## QRP2000 USB-Controlled Synthesizer

### Additional Construction and rework information for V1.1 Printed Circuit Board

This information is only applicable to SDR-Kits with v1.1 Printed Circuit Boards only

*Fig 1 – Position of link to connect Cathode of D3 to ground*

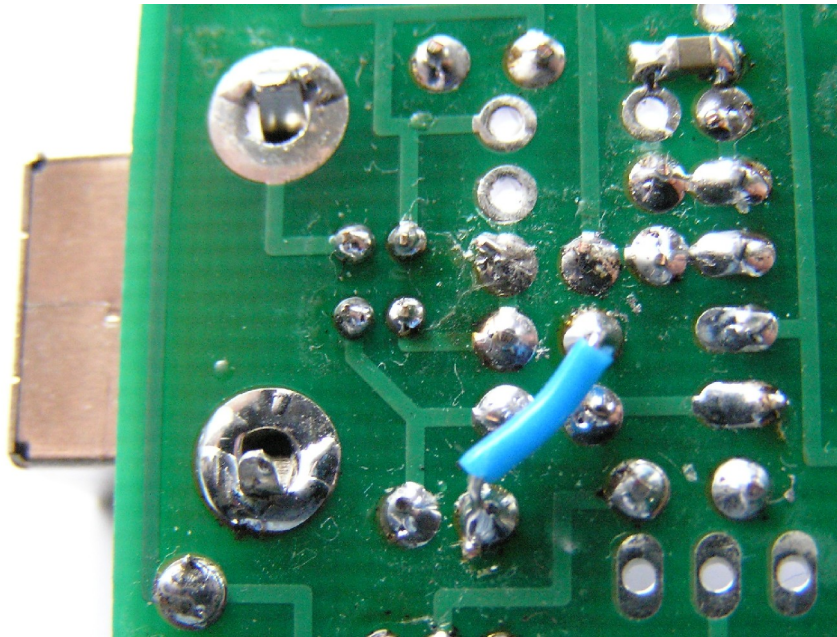
#### **1. Ground pad of D3 not connected**

**Description of Modification:** The anode of Zener diode D3 is floating as the pad and area around it is not connected to ground. This issue should normally not cause an issue in the proper functioning of the USB-Synthesizer but fitting the link is **HIGHLY recommended** to ensure the USB connection to the PC is in accordance with USB specification. Please refer to fig 1 below and fit a short piece of wire between the anode pad of D3 to the nearest ground point, I used the anode of Zener diode D2. Alternatively solder to the ground of the USB socket.

*Figure 2 – USB-Synthesizer Kit PCB V1.1 Component placing*

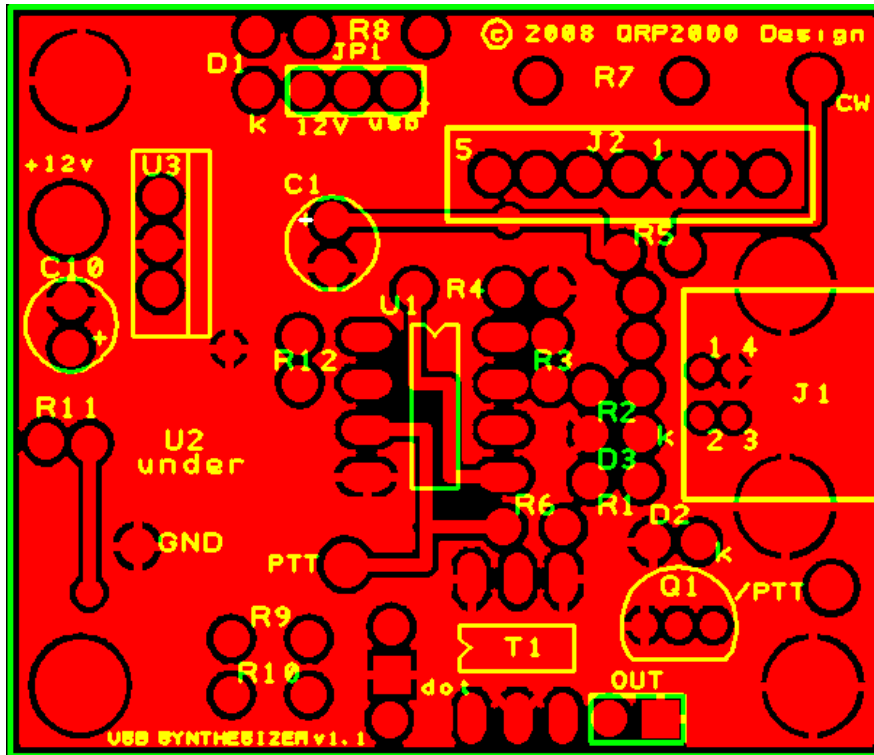
Please refer to [www.SDR-Kits.net](http://www.SDR-Kits.net) for current USB-Synthesizer Kit documentation: Figure 2 below clarifies the component placing of the V1.1 Printed Circuit Board.
